Plan Approval Screen

127 Washinee Heights

Repair Septic System

PROPOSED ADDITION TO THE
KEENAN GUEST HOUSE
 127 WASHINEE HEIGHTS ROAD, TACONIC, CT

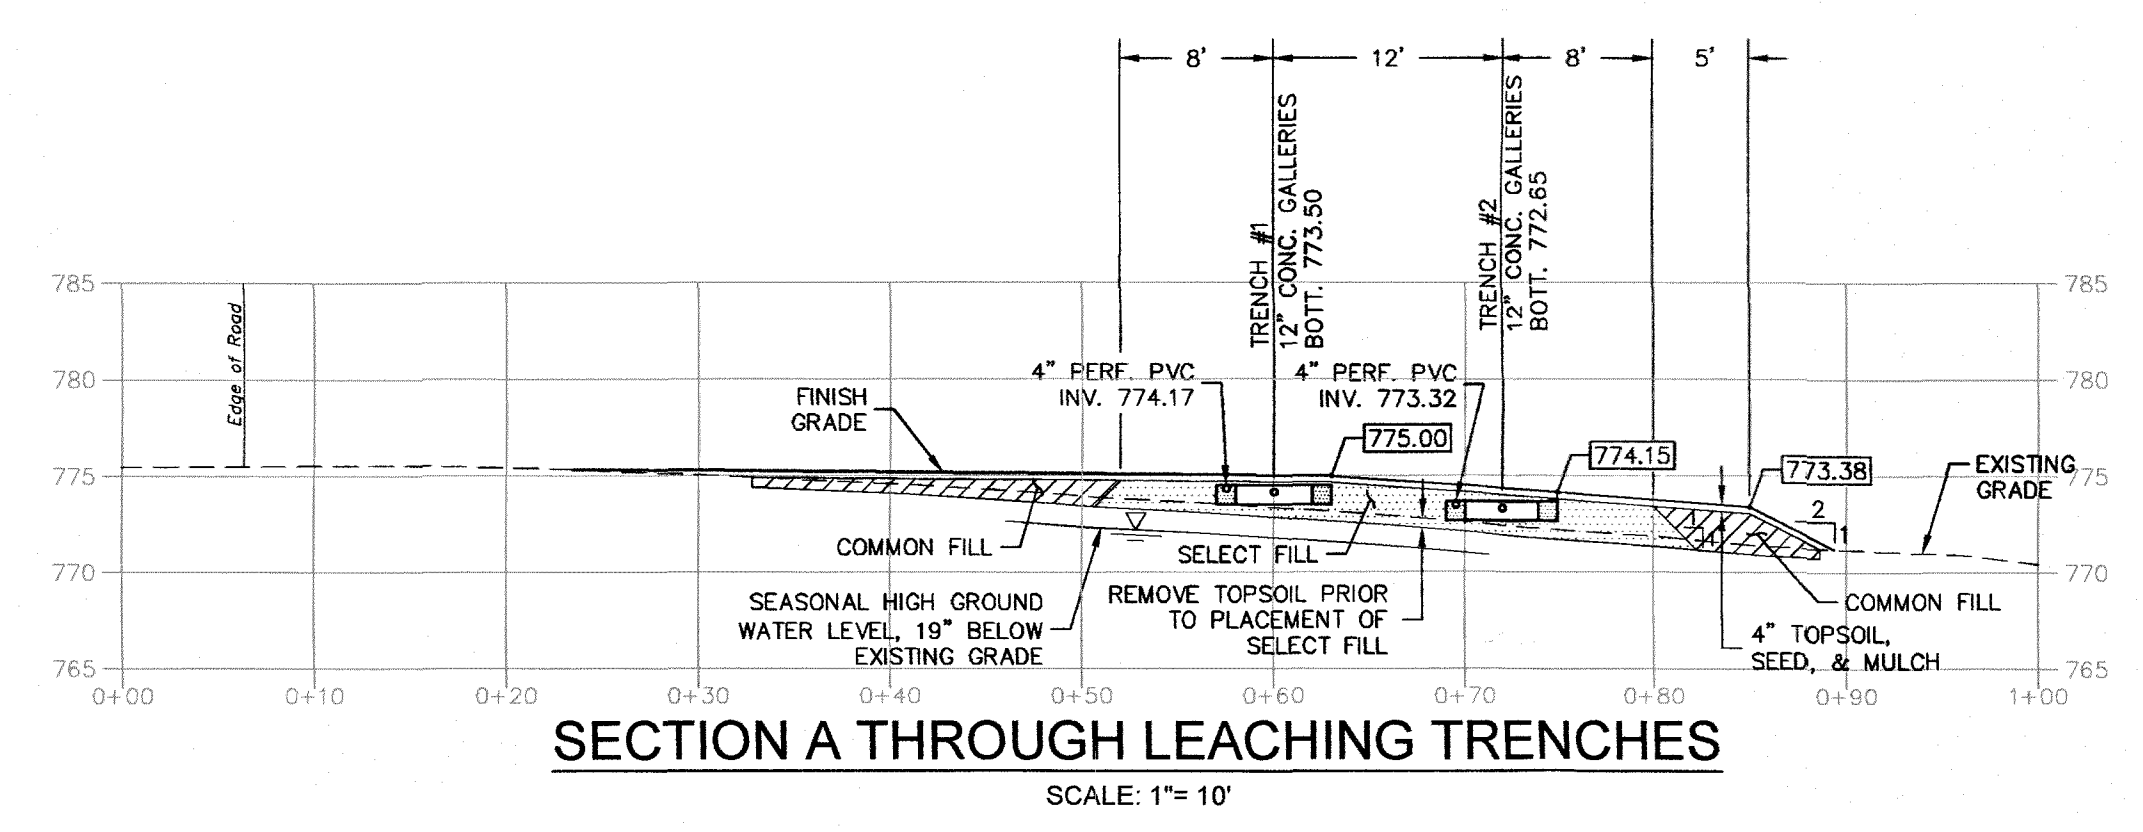
- 1) SEPTIC SYSTEM AND ADDITION TO BE FIELD STAKED BY THE SURVEYOR.
 - 2) DESIGN ENGINEER TO OVERSEE REMOVAL OF DRIVEWAY 25' MINIMUM BROWN GRADIENT FROM LEACH FIELD AND PLACE OF COMPLY MATERIAL IN ITS PLACE.

- 3) INSTALLER TO SUBMIT A REPORT STATE ANALYSIS TO T.A.H.D. PRIOR TO PLACEMENT OF FILL.
 - 4) INSTALLER TO CONTACT T.A.H.D. FOR SCRIPICAT INSPECTION PRIOR TO PLACEMENT OF FILL.

- 5) PER P.E. USE A BAFFLE BOX IN UPPER TRENCH.
 - 6) SEPTIC TANK AND PUMP CHAMBER TO BE TABRO SEALED.
 - 7) NO FOOTING DRAINS MAY BE ADDED ON SOUTH SIDE OF HOUSE (WITHIN 25' OF WALL).

- 8) NO PLUMBING IN THE BARN.
 - 9) SEPTIC SYSTEM AREA MUST REMAIN UNDISTURBED UNTIL INSTALLED.
 - 10) IT IS THE OWNER'S RESPONSIBILITY TO OBTAIN ANY NECESSARY APPROVALS FROM THE INLAND NUTRIENTS COMMISSION.

- NOTE: THE NEIGHBOR HAS APPROVED THE CONSTRUCTION UNLESS ON THEIR PROPERTY NO 101 FILL.
- SYSTEM TO BE INSTALLED WHEN SOIL MOISTURE IS LEAN!
